13th October 2022

File No. 22301

**Re: Minor Variance Application A 2022-126
44 Rusholme Road, Kitchener**

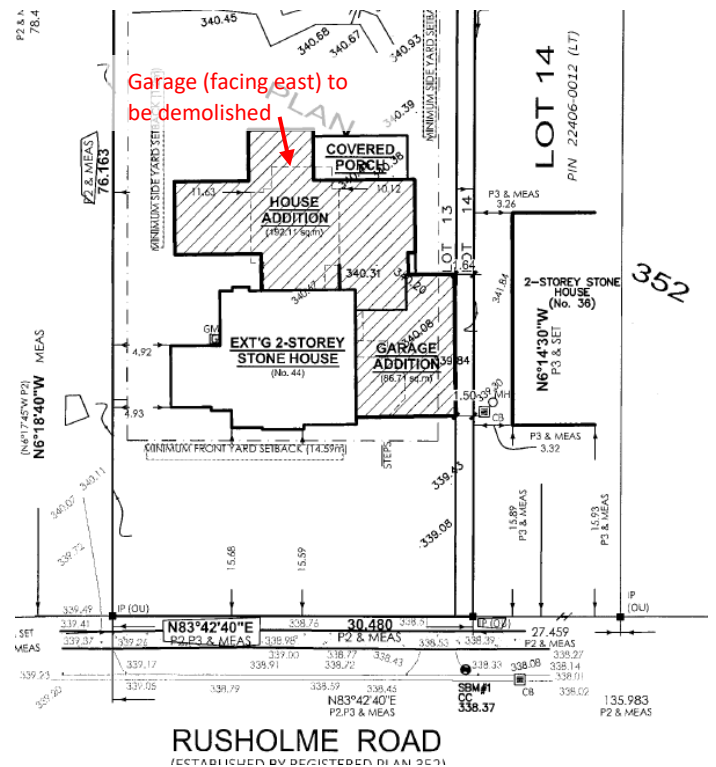
The figure to the right illustrates the proposed addition to 44 Rusholme Road, wherein:

- The existing garage (facing east) is proposed to be demolished;
- New house addition to be constructed to the rear of the existing single detached dwelling; and
- New garage addition proposed to be constructed to the east of the existing single detached dwelling.

There is little detail about the proposal, including:

- The width of the garage (two or three car);
- The height of the garage;
- If the garage will have habitable floor space above the ground floor and/or a third-floor attic or usable space;
- The roof detail, for example roof pitch and height to peak; and
- Fenestration details, windows and/or cladding of the garage.

REASON 4: As illustrated on the Applicant's sketch on Page 2 of this letter, the Levene dwelling has an interior side yard setback of 3.32 metres. The Applicant's west side yard is 4.93 metres; however, they are looking to vary the existing zoning regulation to 1.5m to accommodate their house plans for a large garage addition. While no dimensions of the garage width are provided, it is calculated that it is +9 metres in width, which would accommodate a 3-car garage. While this may be desirable by the owners of 44 Rusholme, it is not necessary and does not fit in the context of the site. Rather, the easterly side yard setback should comply with the minimum 3.0m requirement, in keeping with the other side yard setbacks of the two properties.
